## **Incomplete Application Response**

24-103231-PLN | 2110 Strong Road SE

**A1.0**1

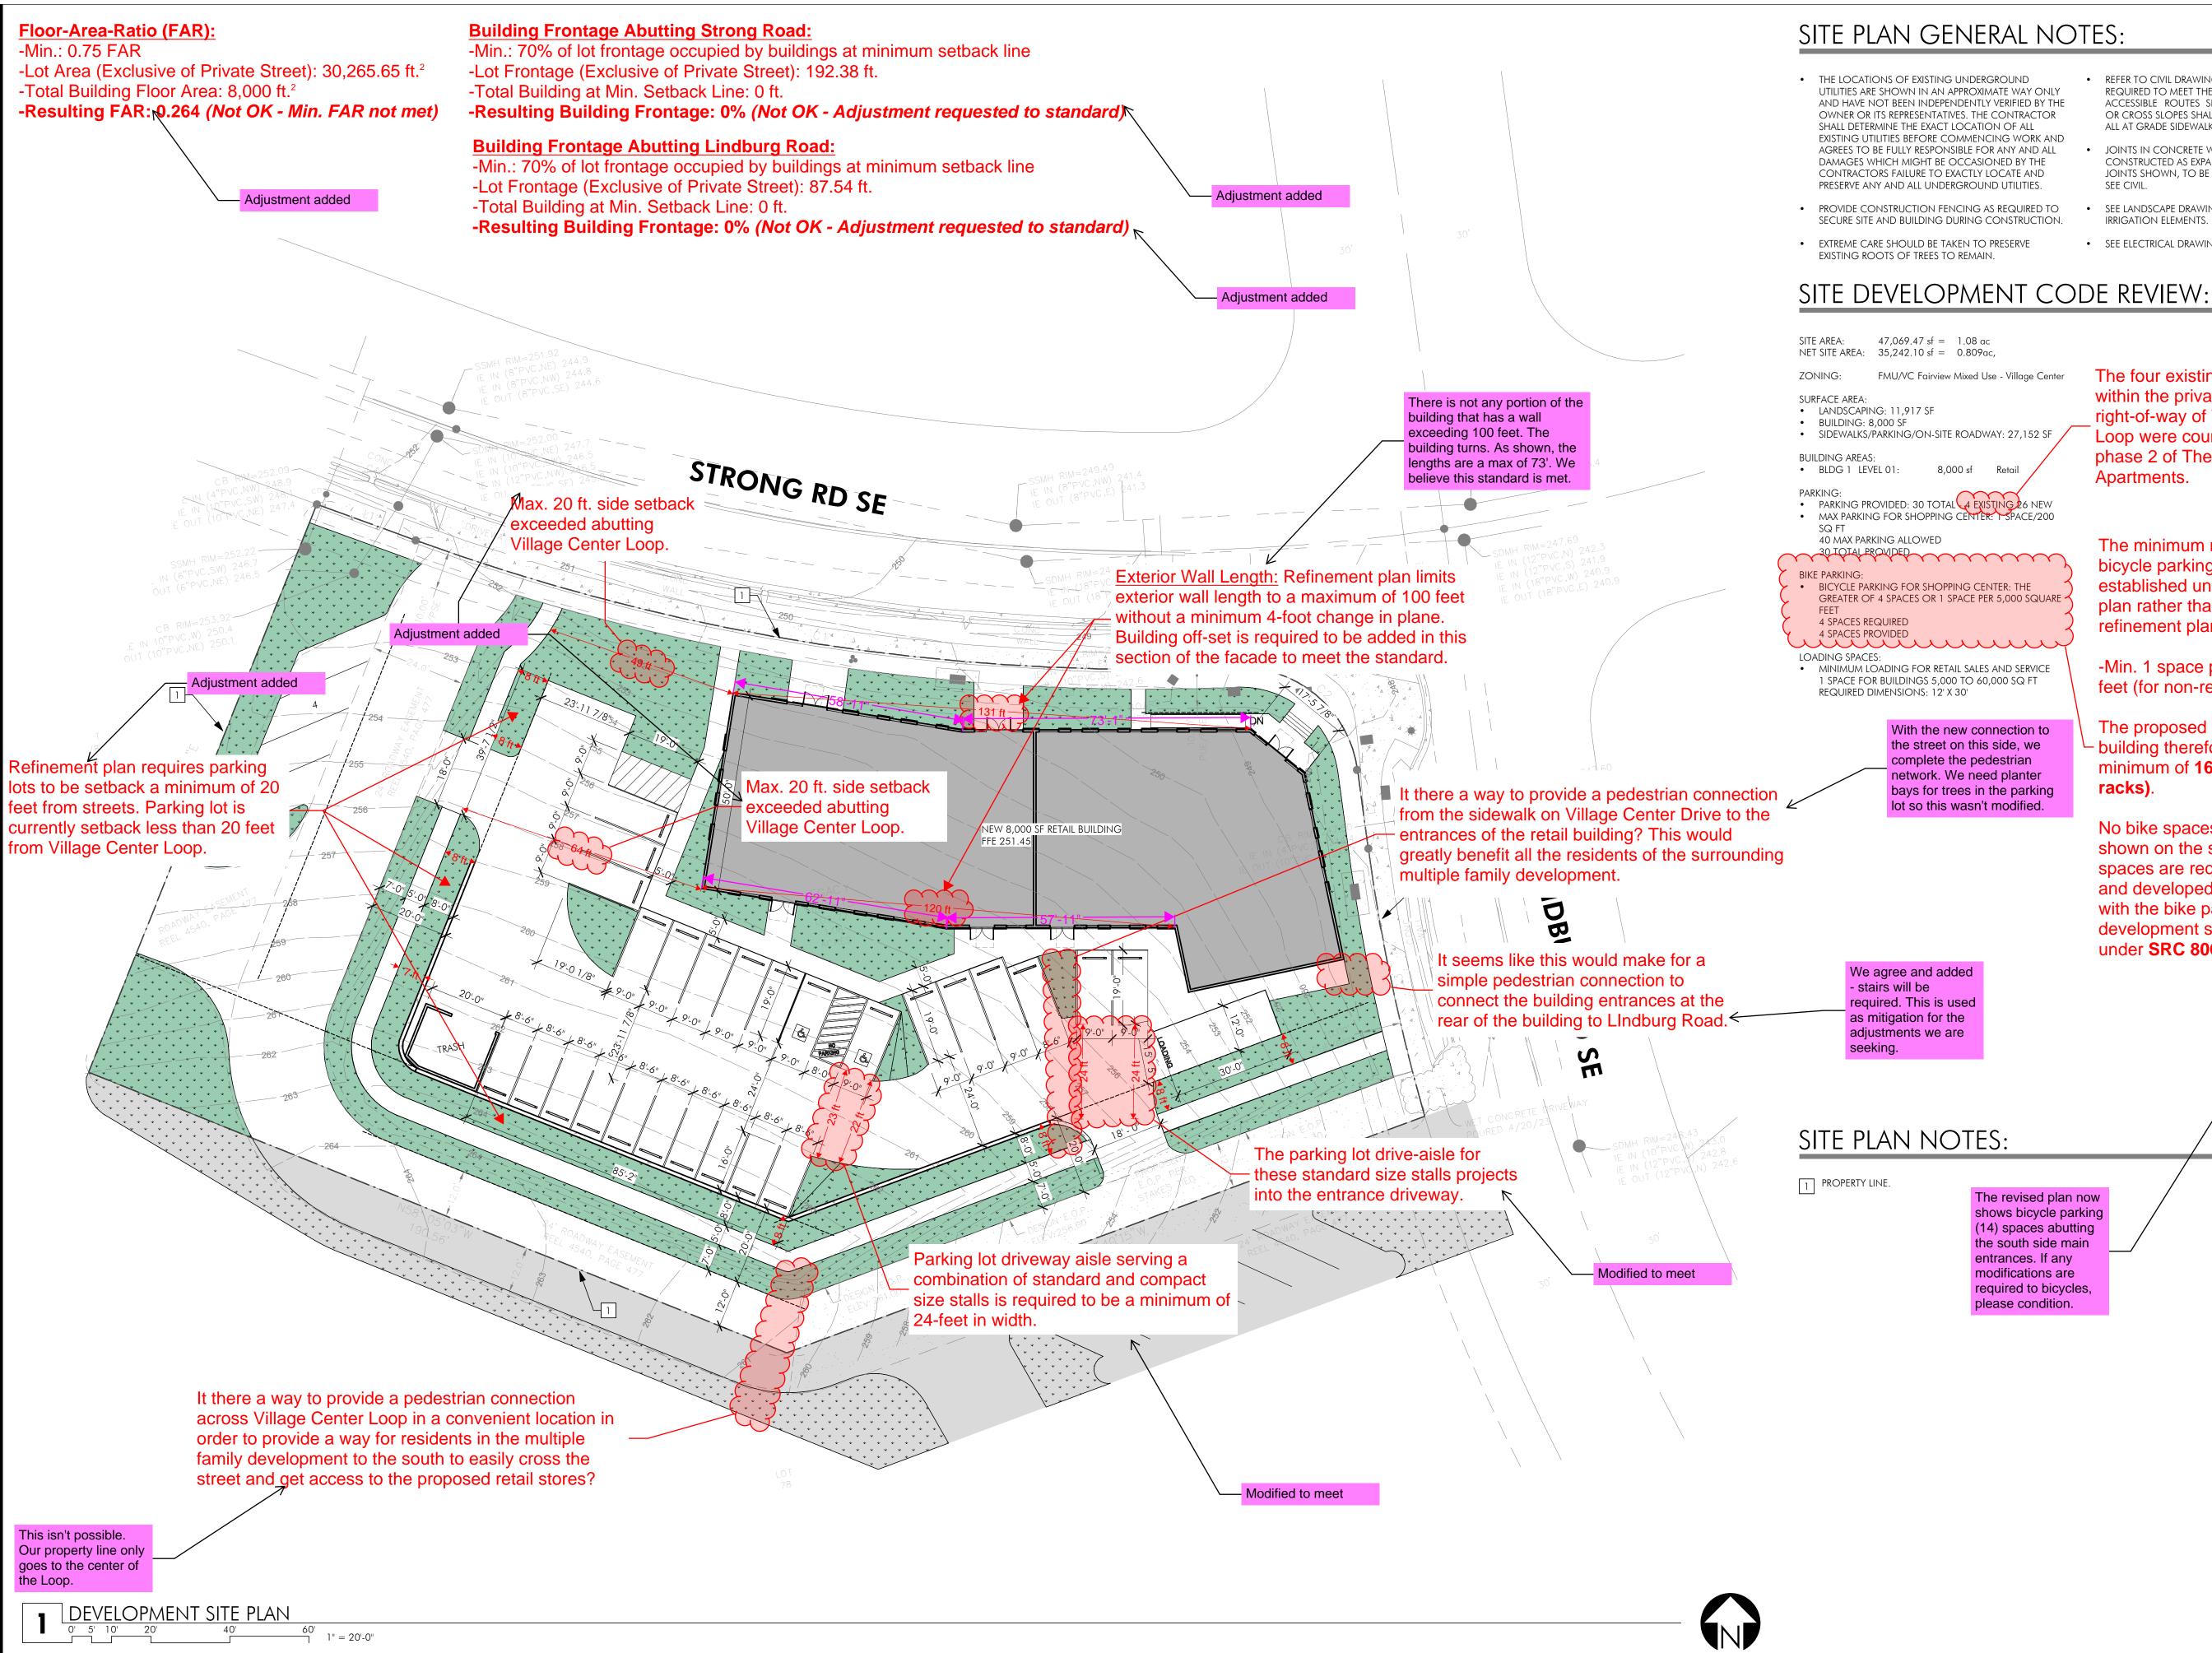
Item 11: Additional Comments on Plans

The four existing spaces located within the private street right-of-way of Village Center Loop were counted as spaces for phase 2 of The Grove

The minimum number of required bicycle parking spaces are established under the refinement plan rather than SRC 806. The refinement plan requires:

-Min. 1 space per 500 square feet (for non-residential).

The proposed 8,000 square-foot - building therefore requires a minimum of 16 spaces (8

No bike spaces are currently shown on the site plan. The bike spaces are required to be located and developed in conformance with the bike parking development standards included under SRC 806.060.

**Applicant's Response:** The applicant has provided responses to comments received on the plans. This item is resolved.
